**STATE OF HAWAII  
DEPARTMENT OF TRANSPORTATION  
HIGHWAYS**

**ADDENDUM NO. 1  
FOR  
INTERSTATE ROUTE H-1, MCCULLY STREET SEPARATION,  
SEISMIC RETROFIT  
FEDERAL-AID PROJECT NO. NH-H1-1(284)  
DISTRICT OF HONOLULU  
ISLAND OF OAHU**

**May 1, 2026**

**BEARING DESIGN DETAILS**

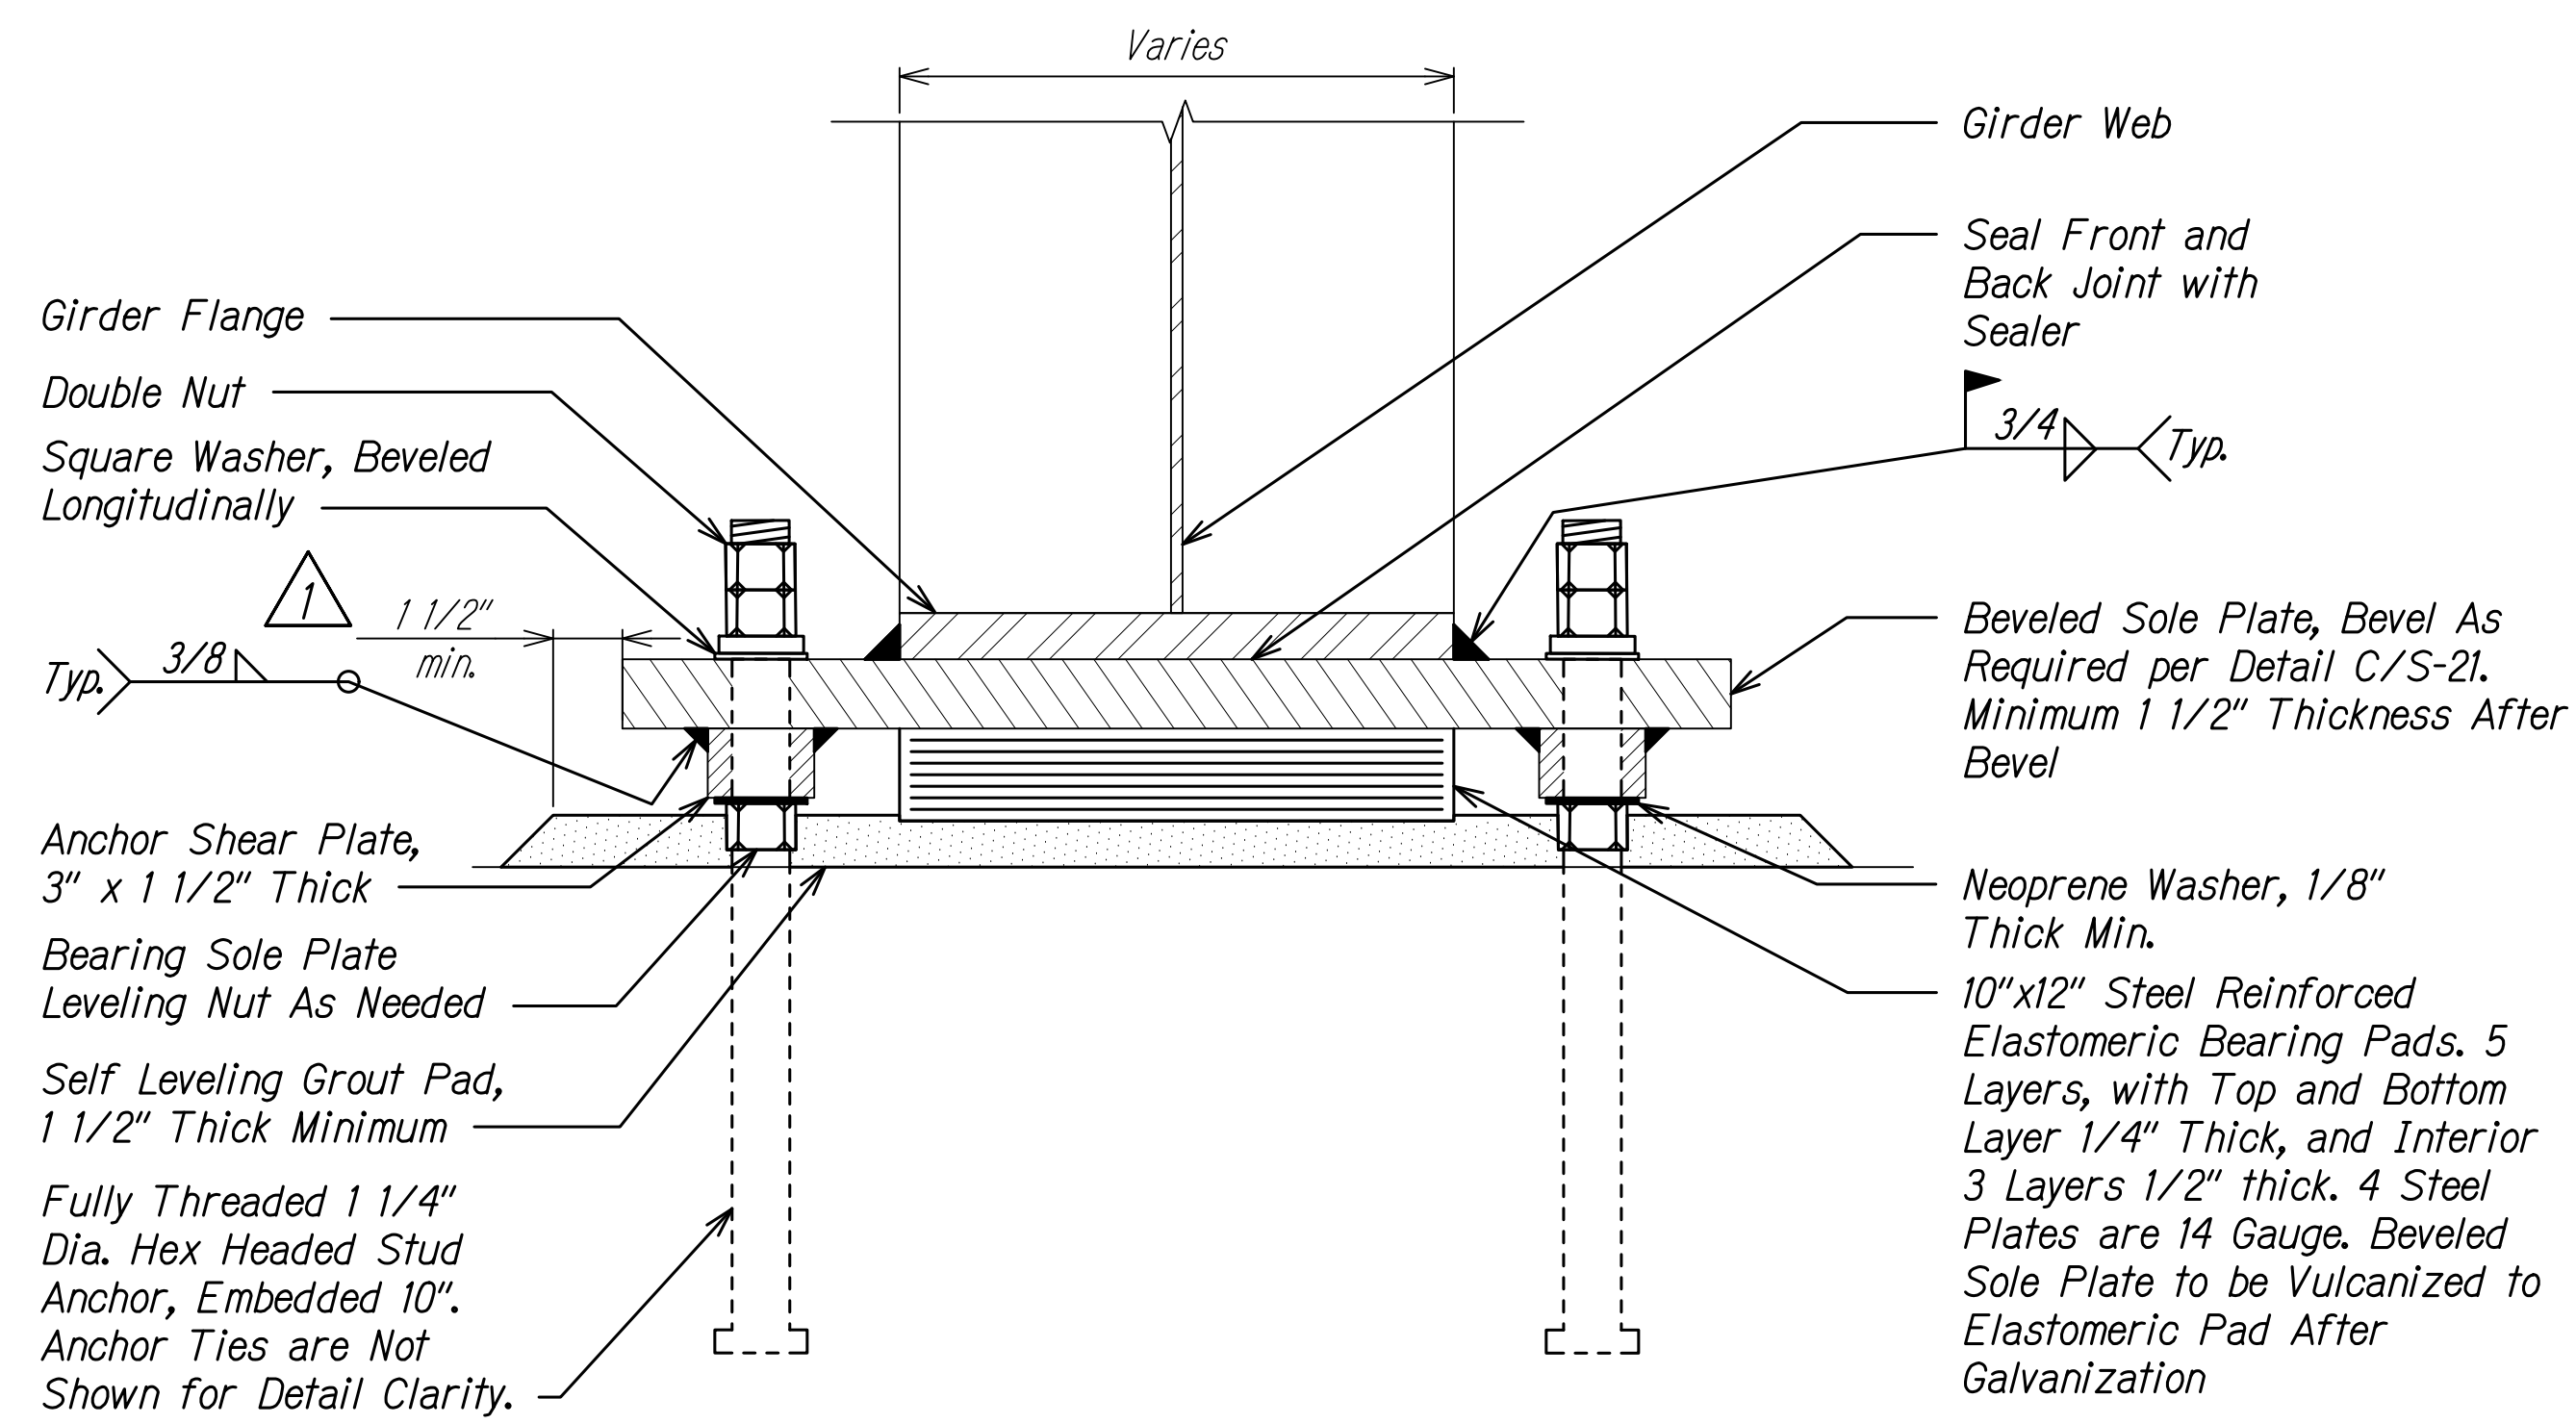
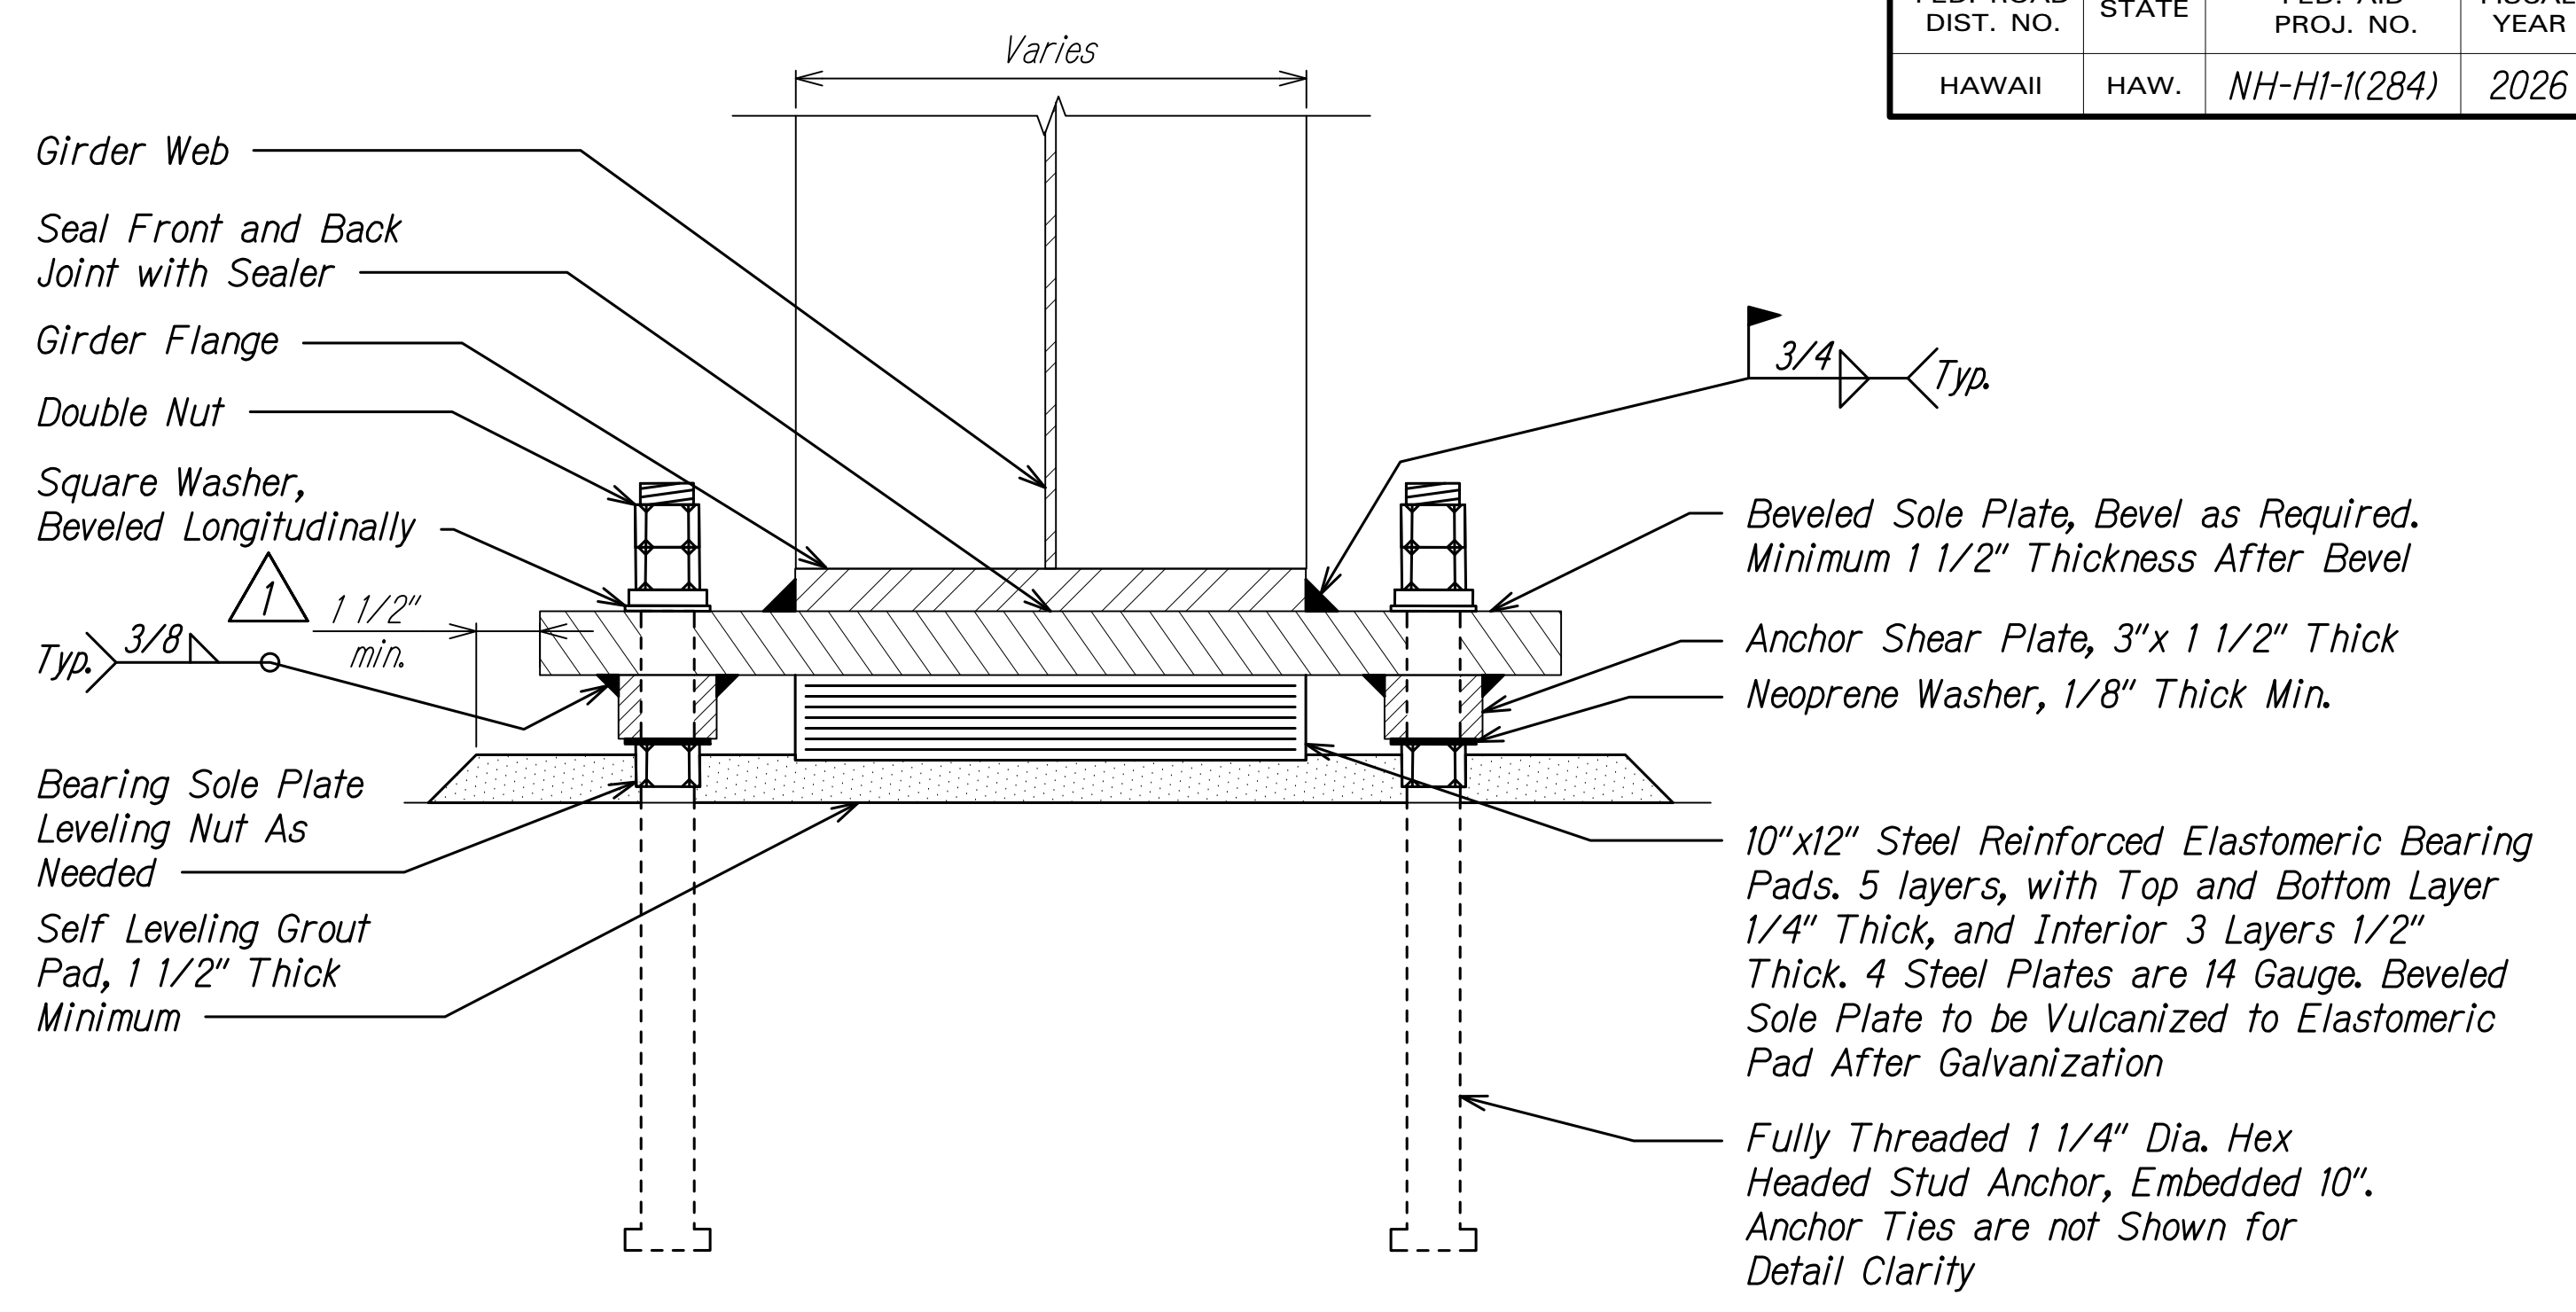
4/21/26	Added grout pad extension dimensions. Rearranged C/S-24 and C/S-24 and revised notes.
DATE	REVISION

10. Grout pad shall extend a minimum of 1 1/2" horizontally on all sides of the bearing.
11. Stud anchor lengths vary by location due to the beveled sole plate. All stud anchors shall meet the minimum embedment of 10" and extend at least 3 full threads above the double nut.
